**ADDITIONAL INFORMATION FOR THE STARWOOD POWER PROJECT,
APPLICATION FOR CERTIFICATION (06-AFC-10)**

Subject: Starwood-Midway Additional Project Information (06-AFC-10)
URS Project No. 27656131.00400

ATTACHMENT A
REVISED PRELIMINARY PLAN

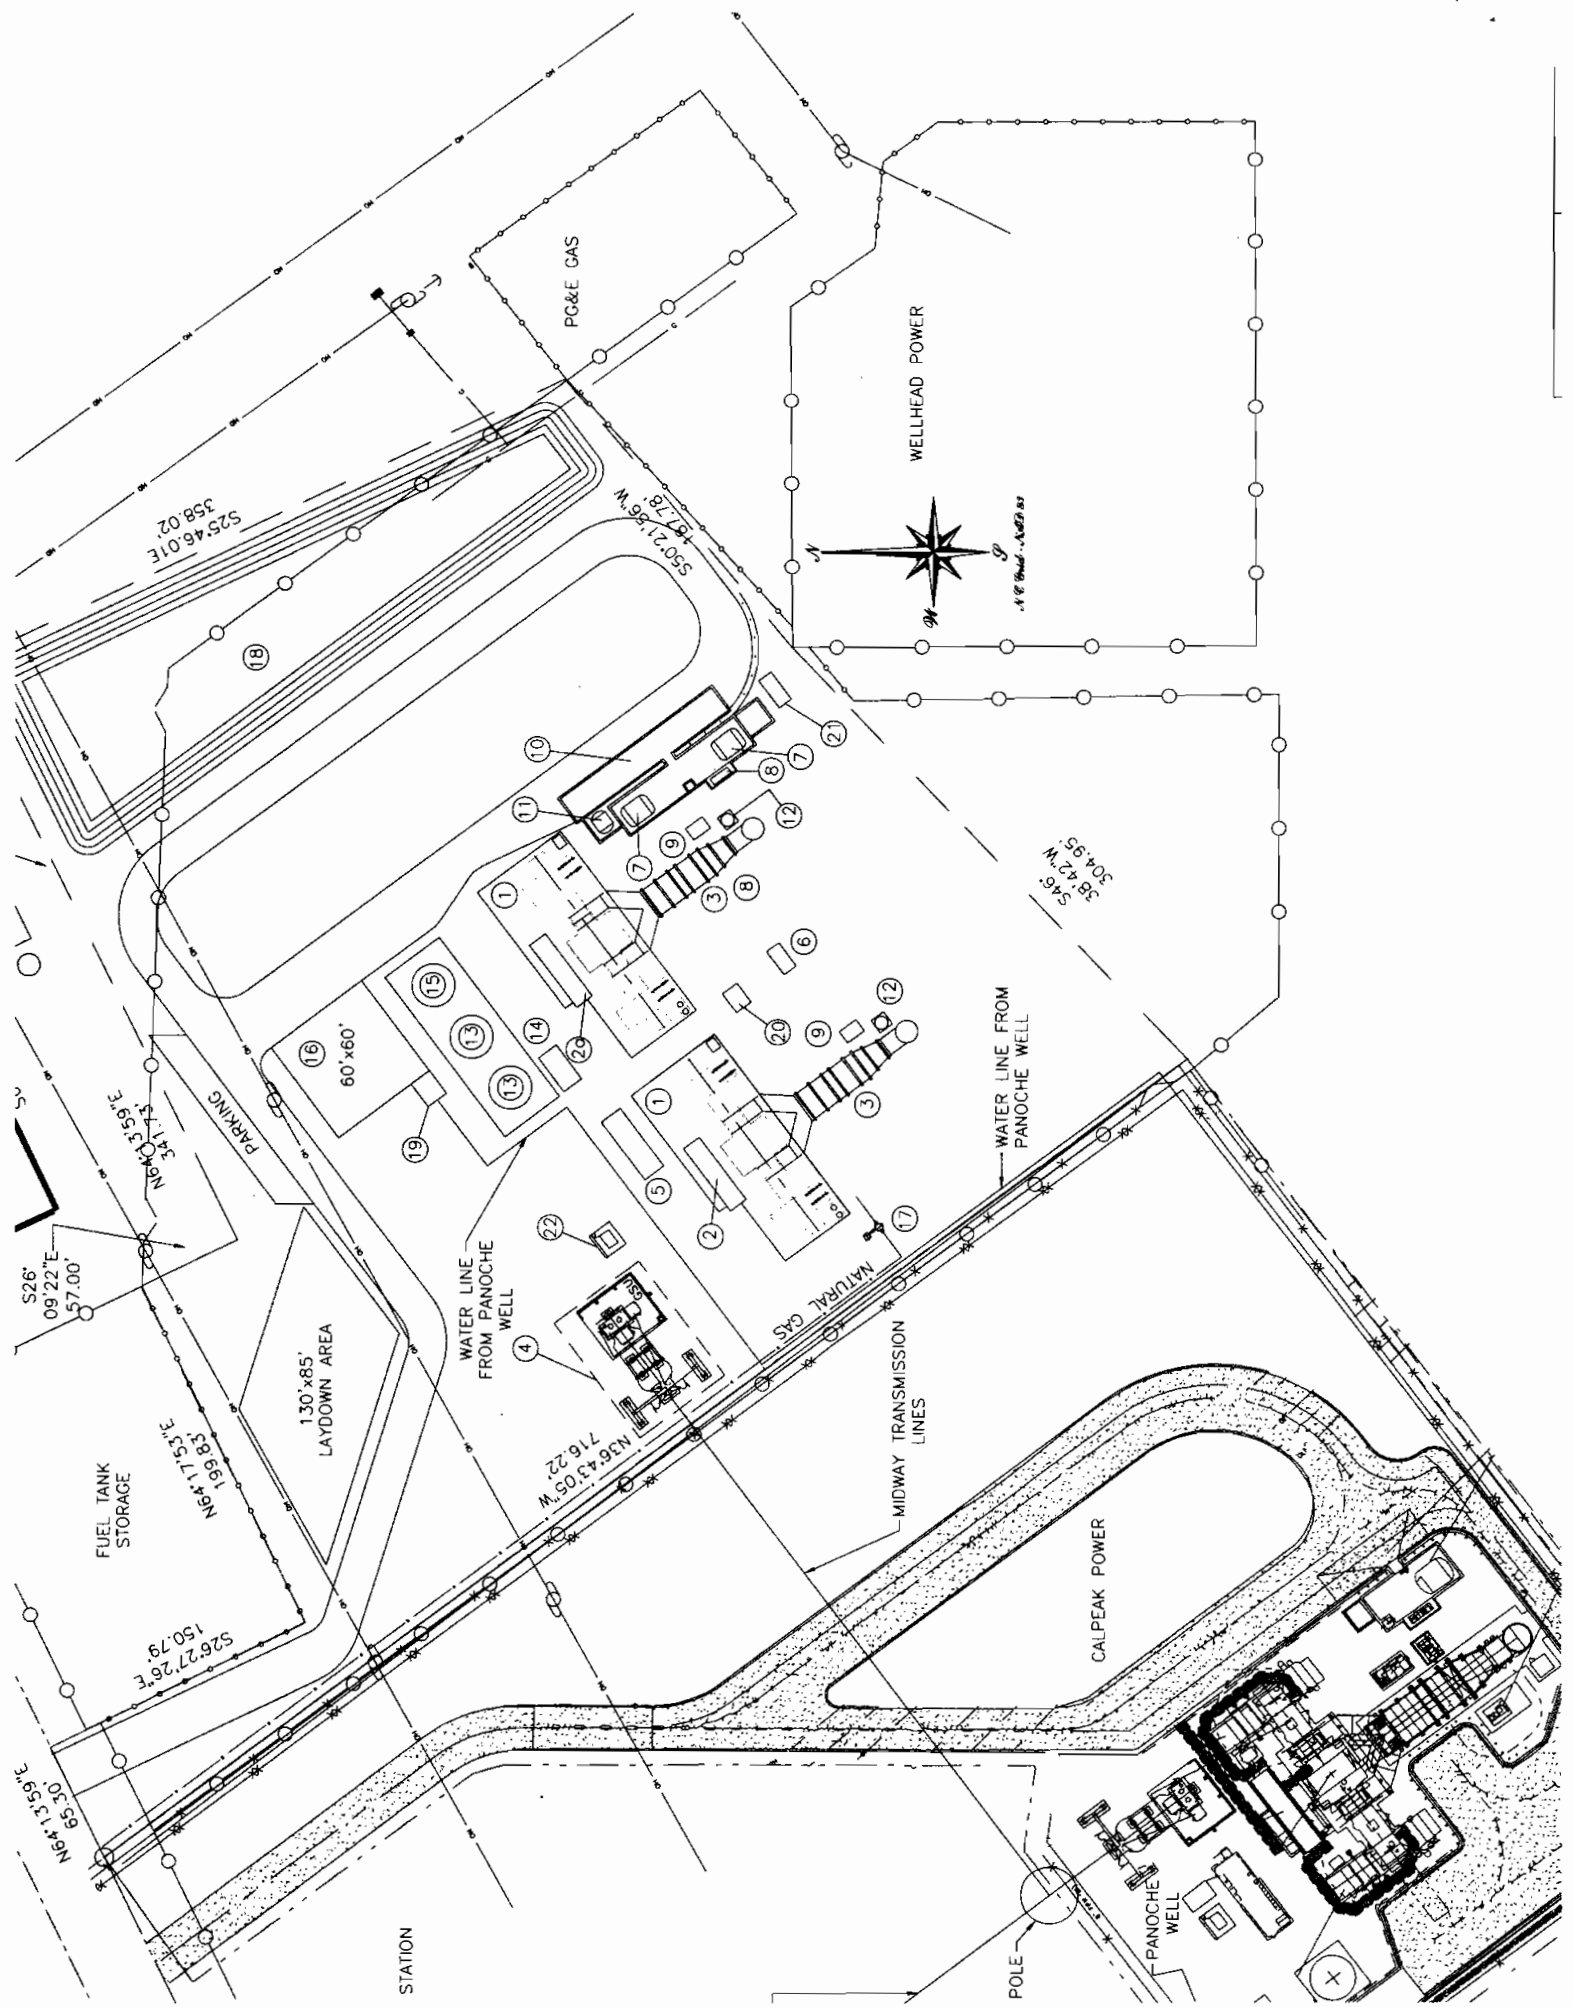
1. Addition of an Oily Water Separator (OWS) on-site to collect oily waste from equipment areas (like transformer containment areas). Effluent (water) will be directed to the on-site evaporation pond. Oils collected will be pumped to a disposal truck and hauled off-site.

2. Relocation of "Waste Water System Above-Ground Storage Tank" (item 21 on previous Preliminary Plan submitted with the Midway AFC). This tank has been renamed as "GT Drain Tank" and relocated/renumbered to item 11 on the Revised Preliminary Plan. The "Wash Down Drain Tank Area" has been removed.

3. Rename "Waste Water System Collection Sump" (item 20 on Revised Preliminary Plan) to "GT Drain Collection Sump". This Gas Turbine Drain Collection Sump along with the OWS (item 21) will collect waste from the GT areas. The OWS will also collect waste from containment areas (transformers) and equipment washdown areas (such as the air compressor/dryer skid).

4. The Auxiliary Transformer has been added to the Revised Preliminary Plan as item 22.
5. Shift the DI Trailer pad (item 16 on Revised Preliminary Plan) to connect to the proposed internal roadway/vehicle turnaround area.

6. As the site is in a floodplain, the top of foundations will be raised 3 feet above existing grade to comply with Fresno County regulations and avoid impacts related to the 100-year flood zone. This modification is in response to Fresno County Site Plan Review (March 7, 2007).

7. The proposed on-site evaporation pond will provide stormwater retention for the Project. This modification is in response to Fresno County Site Plan Review (March 7, 2007).
